OPTIONAL SERVICE BULLETIN OSB 42-127/1 OSB 42NG-067/1

Supersedes OSB 42-127 and OSB 42NG-067

Installation of new Landing Gear Hydraulic Pump Pressure Switch Plug.

Position of Hydraulic control block serial number

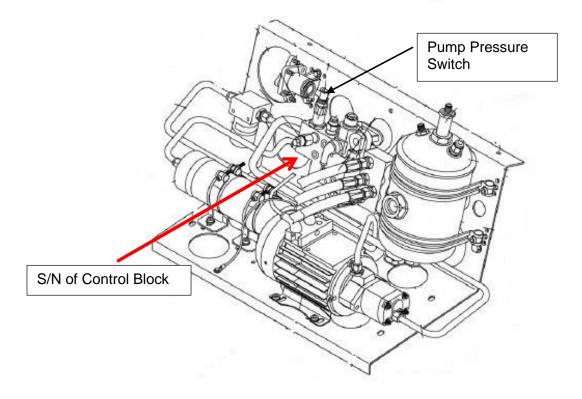
Do the following work steps when you replace the hydraulic control block X11-0003-00-00.00 with S/N up to 0783 by a block with S/N 0784 and subsequent.

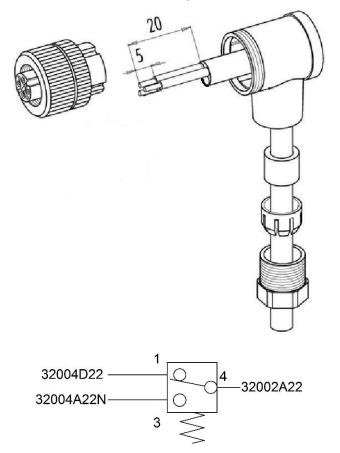
1. Remove the M18x1 female plug from the pump pressure switch and disconnect the plug from the hydraulic control block harness.

2. Prepare the harness and connect i.a.w. figure below.

- 3. Connect the M12x1 plug on the hydraulic pump pressure switch.
- 4. If necessary, fill the hydraulic reservoir with fluid i.a.w AMM Section 29-10.
- 5. If necessary, charge the hydraulic accumulator with Nitrogen.
- 6. Bleed the hydraulic system i.a.w. AMM Section 29-10.
- 7. Do a test for the correct operation of the landing gear extension and retraction system i.a.w. Section 32-30.
- 8. Do a test for the correct operation of the emergency extension system i.a.w. AMM Section 32-30
